BCA & Access Assessment Report

88 Newton Road, Wetherill Park
Lot 1, DP1017259

Prepared for:
Centuria Capital

Revision 1
10th April, 2024
Reference: 230198

Figure 2: Non-Compliant PVA around the development

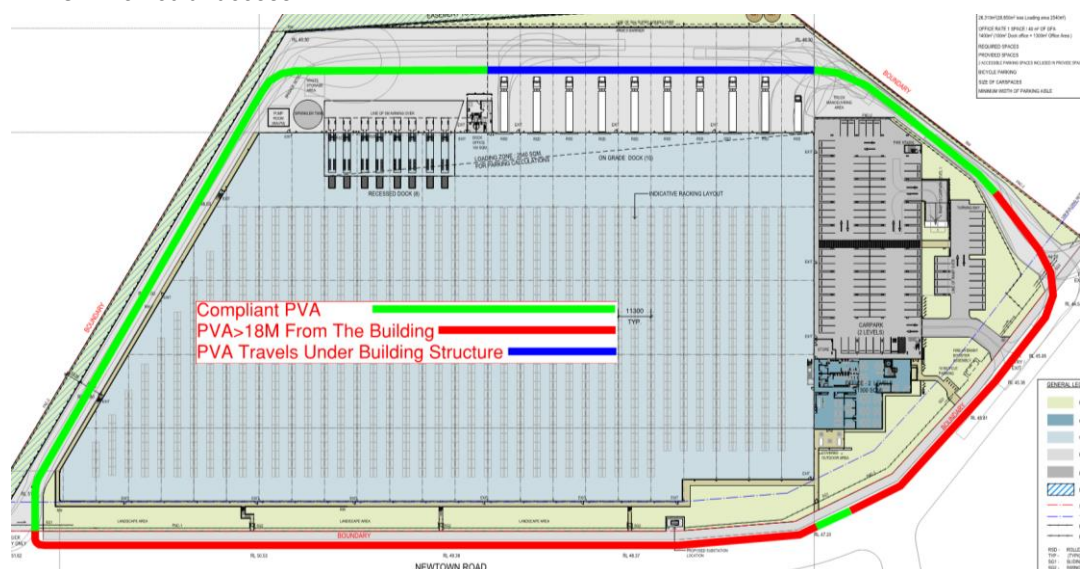
Comment: The proposed building does not comply with the provisions of C3D5 and thus the following non-compliance issues are required to be addressed as a Performance Solution by the Fire Engineer to demonstrate compliance with Performance Requirement C1P9. The below Markup also demonstrates the non-compliant PVA pathway areas around the development.

Note 2: The driveways providing vehicular perimeter access must be designed with adequate loading capacities, gradients and swept paths to accommodate a fire truck, having regard to the FRNSW Fire Safety Guideline – Access for Fire Brigade Vehicles and Firefighters.

Note 3: The Trial Design for the Fire Engineered Performance Solution must take into consideration and detail the proposed security access to the site and how this may impact on FRNSW vehicular access.
